Work Order ID 65948

Item Name: 205 Skidtube bent detail

DESIGN <i>[Signature]</i>	DRAWN BY <i>[Signature]</i>	DART AEROSPACE LTD HAWKESBURY, ONTARIO, CANADA	
CHECKED <i>[Signature]</i>	APPROVED <i>[Signature]</i>	DRAWING NO. D2580	REV. D SHEET 1 OF 3
DATE 07.02.27		TITLE 205 SKIDTUBE ASSEMBLY	SCALE NTS
A	96.09.16	NEW ISSUE	
B	96.12.02	AS MANUFACTURED	
C	98.08.26	REDRAWN, INCLUDED DEO 9094/9097	
D	07.02.27	CHANGE TO SS WEARPLATES AND GASKETS, INCLUDE DEO 9124/9183

DRAWING NO. D2580	TITLE 205 SKIDTUBE ASSEMBLY	REV. D	DART AEROSPACE LTD ENGINEERING ORDER		D.E.O. NO. D2580-D-1	SHEET NO. SHEET 1 OF 1	SCALE NTS
DRAWN <i>UP</i>	CHECKED <i>L</i>	MFG. APPR. <i>R</i>	APPROVED <i>MP</i>		DE APPR. <i>MP</i>		
DATE 10.09.22	DATE 10.11.04	DATE 10.11.04	DATE 10/11/04		DATE 10.11.04

SECTION D-D & SECTION H-H ARE AMENDED AS FOLLOWS:

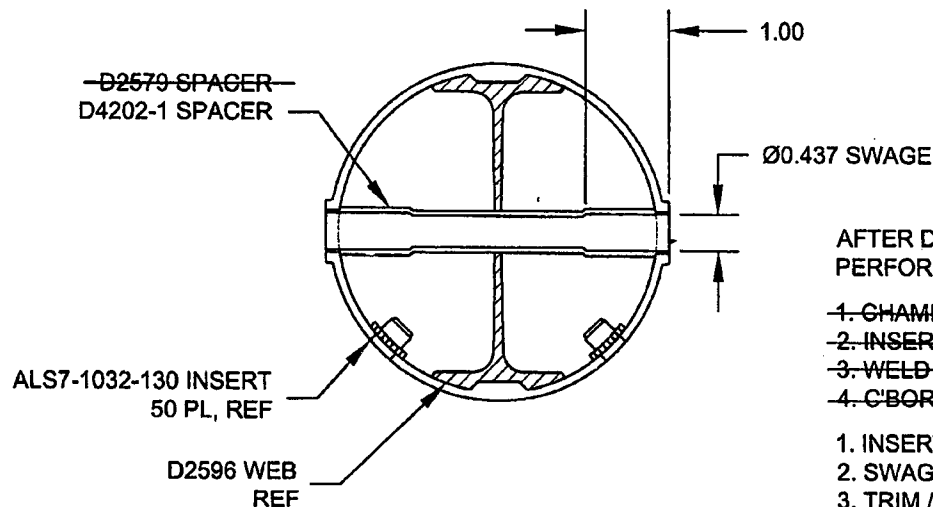
PURPOSE:

CHANGE ALL WELDED CROSSBOLT SPACERS TO SWAGED SPACERS

AFTER DRILLING AND BENDING ASSEMBLY
PERFORM THE FOLLOWING FOR Ø0.508 HOLES ONLY:

1. CHAMFER HOLE 0.050 X 45°
2. INSERT D2579 SPACER (20 PLACES)
3. WELD INTO PLACE AND GRIND FLUSH
4. C'BORE D2579 SPACER TO Ø0.437 X 1.00 DEEP

1. INSERT D4202-1 SPACER, 20 PL (-041) OR 24 PL (-045)
2. SWAGE TO Ø0.437 X 1.00 DEEP PER QSI 002
3. TRIM / GRIND FLUSH PER QSI 002
